**PLANNED UNIT DEVELOPMENT
& SUBDIVISION STAFF REPORT****Date: September 4, 2014****DEVELOPMENT NAME**

Eastridge Place Subdivision, Resubdivision of Lots 8-12

Planned Unit Development Approval to amend a previously approved Planned Unit Development to adjust boundary lines for five existing lots, increase site coverage, and adjust front and side yard setbacks, and Subdivision approval to resubdivide five existing lots of record and one metes-and-bounds parcel into five legal lots of record.

SITE PLAN

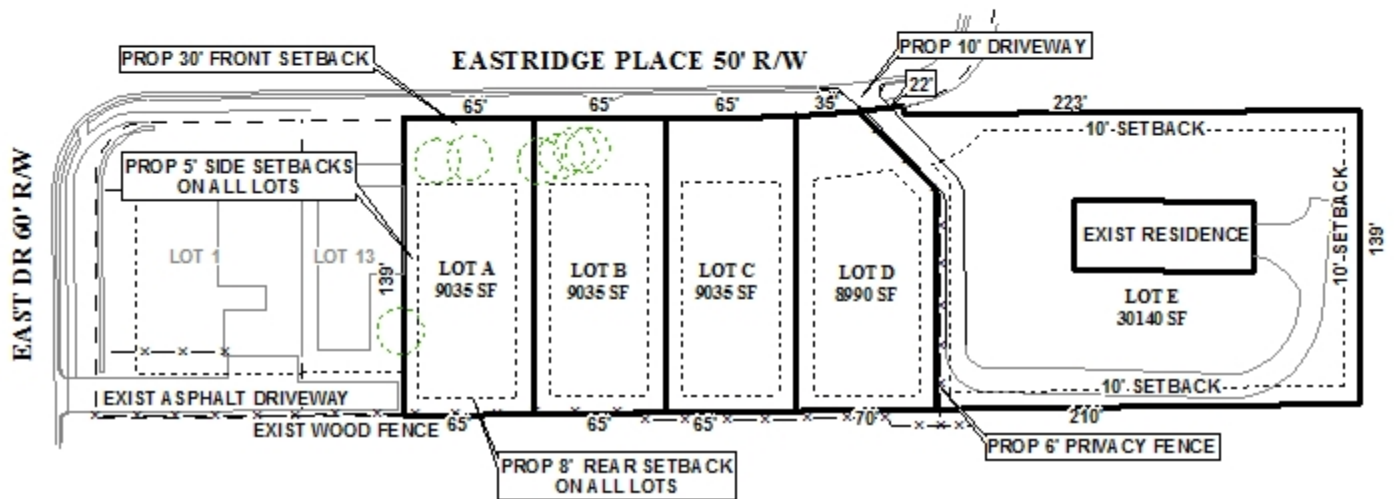
Driveway number, size, location and design to be approved by Traffic Engineering and conform to AASHTO standards. Given the limited lot frontage for Proposed Lot D, the encroachment of the driveway from Lot E, and the power transformer, it may be in the owner's best interest to coordinate the location of the driveway for Lot D and include its location on the PUD.

The applicant now proposes to resubdivide and expand the five recorded lots into four lots (Lots A-D), and to create public street frontage along Eastridge Place for the fifth lot (Lot E) which is currently the metes-and-bounds parcel. The existing 20' rear ingress and egress easement is proposed to be eliminated East of existing Lot 13 and access to the four new resubdivided lots will also be strictly via Eastridge Place.

All lots will meet the minimum size requirements of the Subdivision Regulations. Lots A, B and C would be 65' wide, and Lot D would be 70' wide at the building setback line. Lots A-D would have 5' side yards on both sides, with 10' of combined side yards, less than the 20' required by the Zoning Ordinance, and would still have 45% maximum site coverage. A 30' front minimum building setback line is proposed and a standard 8' rear setback is proposed. Lot E is not part of

the PUD and would be compliant with regard to setbacks and would be limited to the standard 35% maximum site coverage. However, Lot E could effectively be considered a flag lot due to its foreshortened “pole” at the street frontage and it would be less than 60’ wide at the building setback line. Due to agreements between property owners to settle a lengthy dispute, Lot E cannot be given more than the proposed 22’ of public street frontage; therefore, a waiver of Section V.D.1. of the Subdivision Regulations would be required. As for the required 60’ minimum lot width at the building setback line, there is sufficient area on Lot E to adjust the setback line further inward to achieve the required 60’ width.

As a means of access management, a note should be required on the Final Plat stating that each lot is limited to one curb cut to Eastridge Place, with the size, location and design to be approved by Traffic Engineering and conform to AASHTO standards. A note should also be required on the Final Plat stating that Lot A is denied access to the remaining portion of the 20’ easement for ingress and egress to the West.

The lots are labeled with their sizes in square feet on the plat. The plat should be revised to label all lots with their sizes in both square feet and acres, or a table should be furnished on the Final Plat providing the same information.

- 1) retention of all building setback lines, as proposed, for Lots A-D;
- 2) revision of the minimum building setback line for Lot E so as to be measured where the lot is at least 60’ wide, and retention of all other setbacks for that lot;

- 3) placement of a note on the Final Plat stating that Lots A-D are limited to 45% maximum site coverage;
- 4) placement of a note on the Final Plat stating that Lot E is limited to 35% maximum site coverage;

- 5) placement of a note on the Final Plat stating that all lots are limited to one curb cut to Eastridge Place, with the size, location and design to be approved by Traffic Engineering and conform to AASHTO standards;

- 6) placement of a note on the Final Plat stating that Lot A is denied access to the remaining portion of the 20’ easement for ingress and egress to the West;

- 7) revision of the plat to label all lots with their sizes in both square feet and acres, or the furnishing of a table on the Final Plat providing the same information;

- 1) retention of all building setback lines, as proposed, for Lots A-D;

- 2) revision of the minimum building setback line for Lot E so as to be measured where the lot is at least 60' wide, and retention of all other setbacks for that lot;

- 3) placement of a note on the site plan stating that Lots A-D are limited to 45% maximum site coverage;
- 4) placement of a note on the site plan stating that all lots are limited to one curb cut to Eastridge Place, with the size, location and design to be approved by Traffic Engineering and conform to AASHTO standards;

- 5) placement of a note on the site plan stating that Lot A is denied access to the remaining portion of the 20' easement for ingress and egress to the West;

- 6) revision of the site plan to label all lots with their sizes in both square feet and acres, or the furnishing of a table on the site plan providing the same information;
